VILLAGE OF CALDWELL
NOBLE COUNTY, OHIO
PRISON PUMP STATION

ADDENDUM #2

JULY 9, 2026

THRASHER PROJECT #T20-11309

ELECTRICAL SITE PLAN

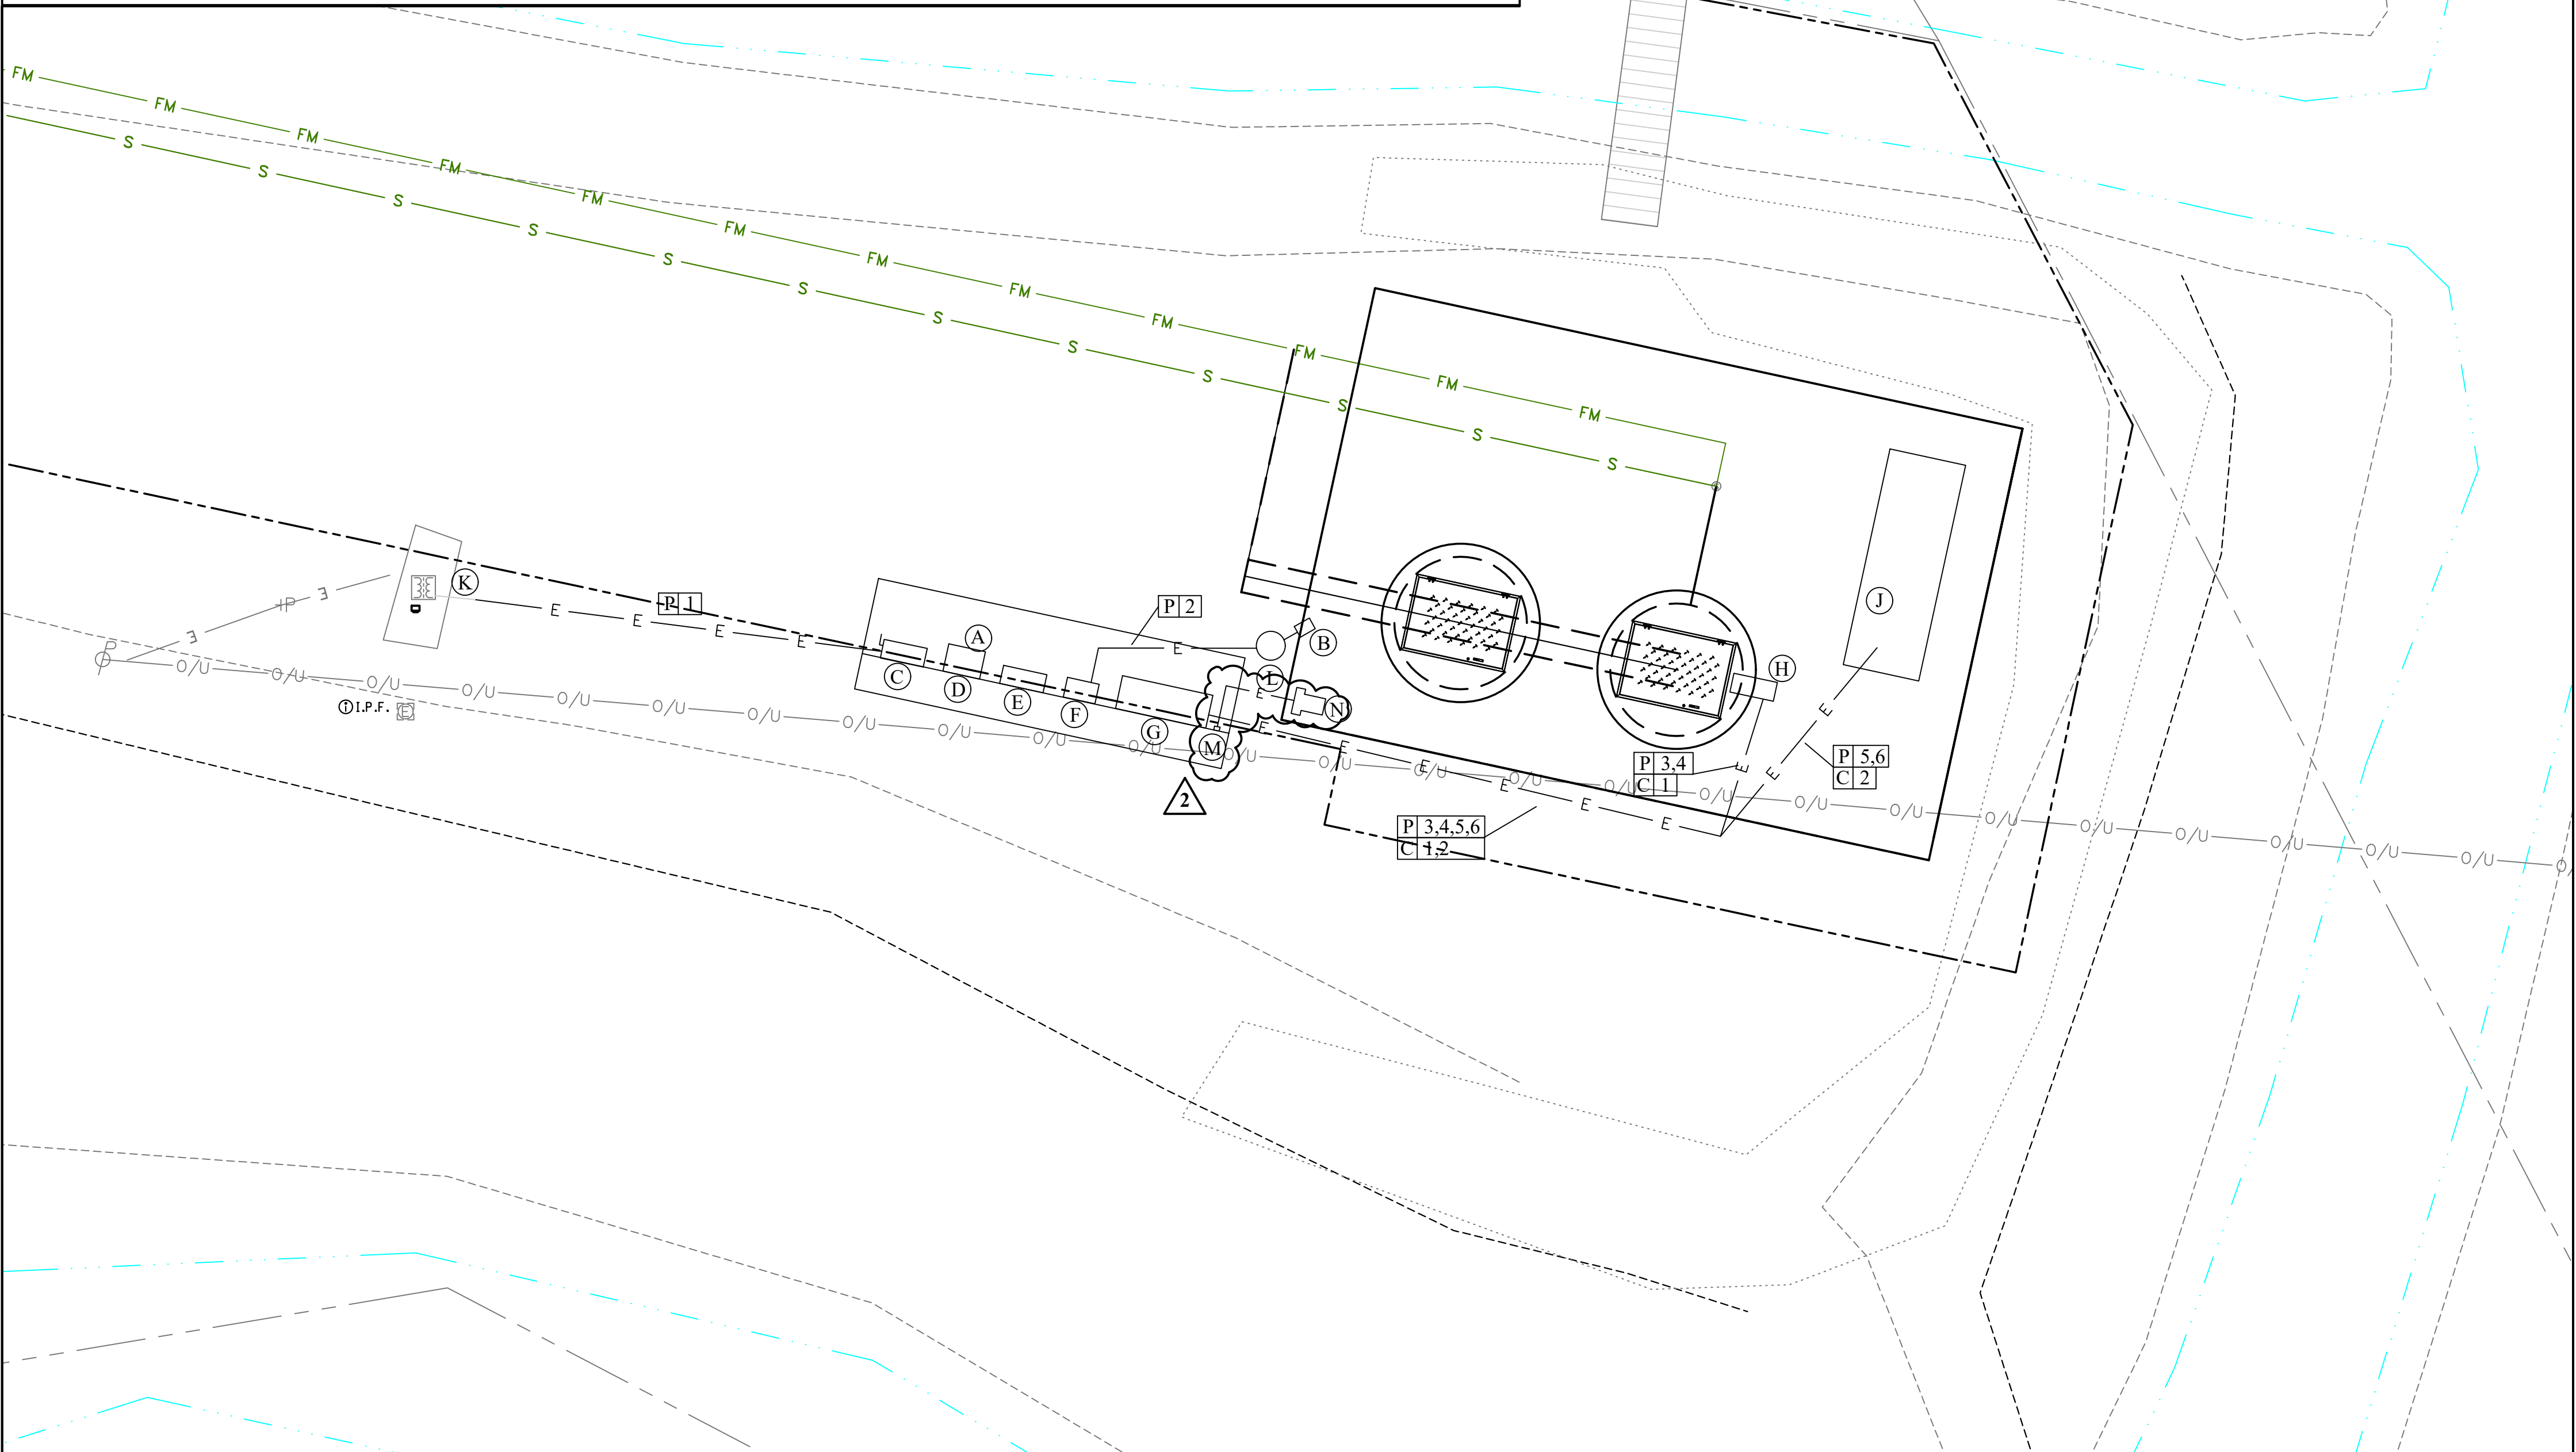
1	CLW	07/08/26	ADDENDUM No.2-ADDED AIR BLOWER	
NO.	BY	DATE	DESCRIPTION
